FF-L-2740  
INT. AMENDMENT-3  
December 3, 1994  
SUPERSEDING  
Int. Amendment-2  
February 25, 1994

INTERIM AMENDMENT  
TO  
FEDERAL SPECIFICATION  
LOCKS, COMBINATION

For combination locks:

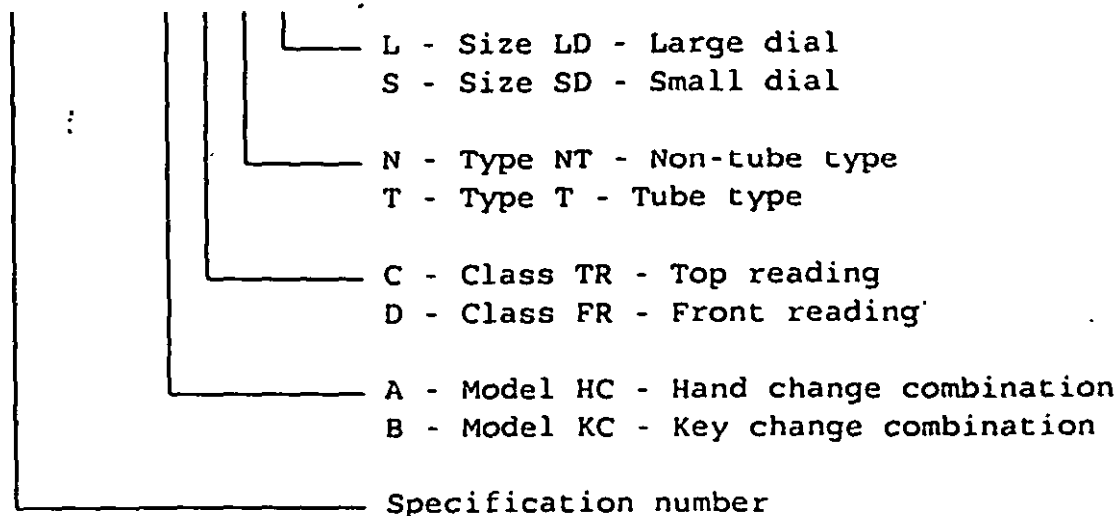
Delete paragraph 6.5 and substitute the following:

6.5 Reference identification number. The reference identification number (RIN) system may be used for items covered by this specification. An example of the RIN is as follows:

FFL2740- A C N S

FIGURE 1  
 Schematic arrangement of lock case holes.

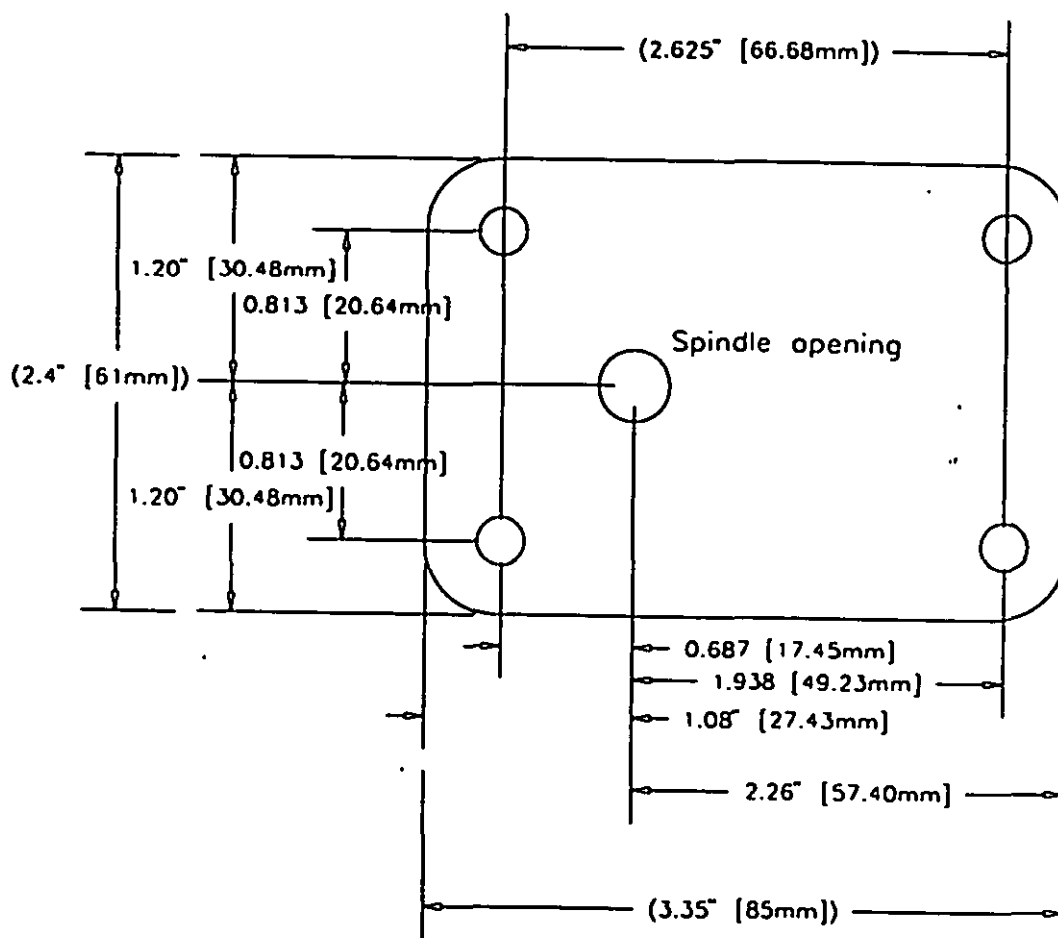
Delete Figure 1 and substitute the attached Figure 1.

Tolerances:  
 XX.XX ±0.01 [±0.25 mm]  
 XX.XXX ±0.005 [±0.13 mm]

Figure 2a - Case and Bolt Strength Test

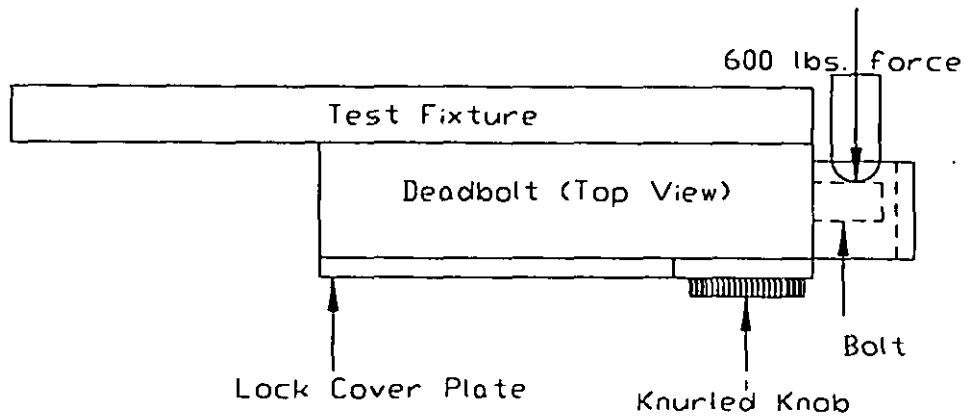
4.5.2.3.2 Configuration II. Mount the lock on a test stand as shown in Figure 2A. Apply a force of 600 pounds to the bolt as shown in the Figure. Examine the case and bolt for damage. Any fracture or bending of the bolt or case shall be a failure. Apply a force of 200 pounds to the bolt as shown in Figure 3A. Any fracture or bending of the bolt or case, or damage to internal components shall be a failure.

Add new Figures 2a, 3a, 4 and 5.

Figure 4 - Test Fixture Configuration

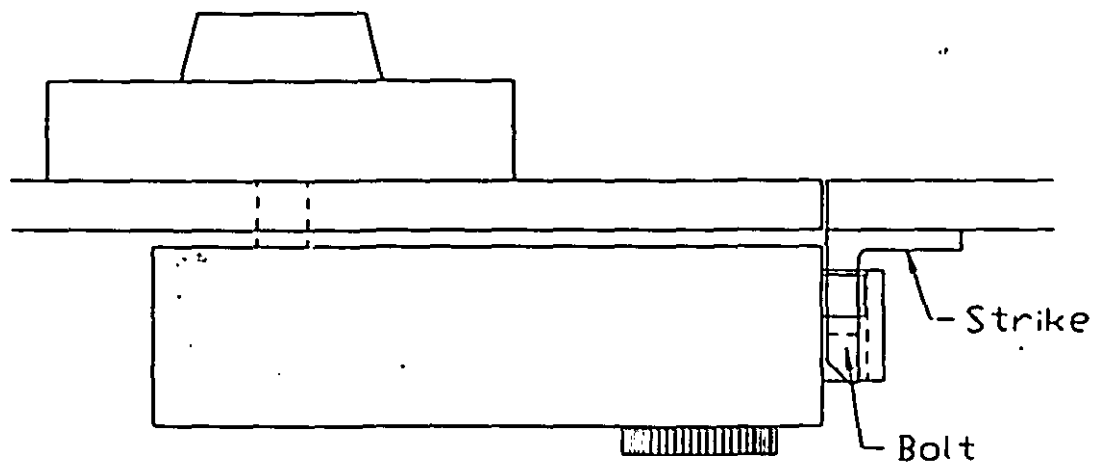
- (1) Vertically mounted, 3/8 inch thick steel plate approx. 19 inches wide by 11 inches.
  - (2) Drilled and topped to allow for mounting deadbolt.
  - (3) Hinged to allow for cyclic test using strike.
- Alternatively, the lock may be mounted to a fixed plate with the strike mounted to a moveable fixture.

FIGURE 5 - Strike Configurations

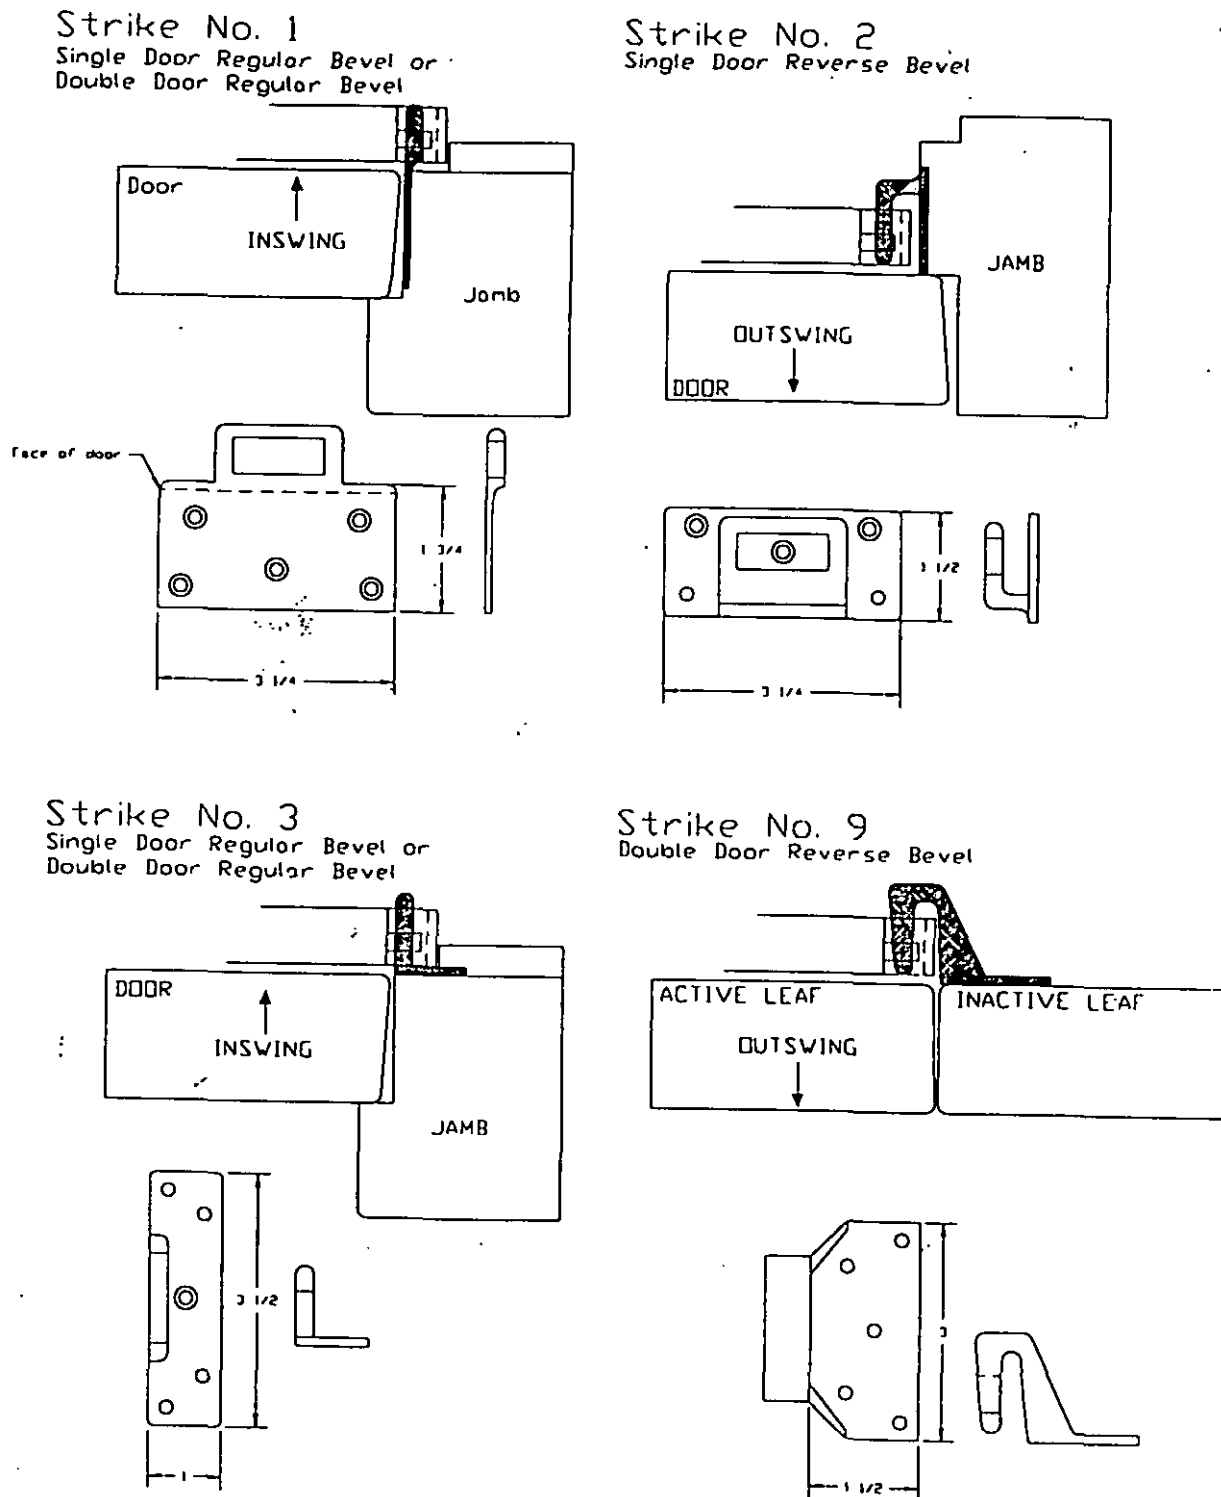
3.4.15 Strikes. The pedestrian door lock shall have interlocking strikes to prevent jamming or spreading the door frame. The strikes shall be as shown in Figure 5. Each deadbolt shall be furnished with a strike as specified (see 6.5.2).
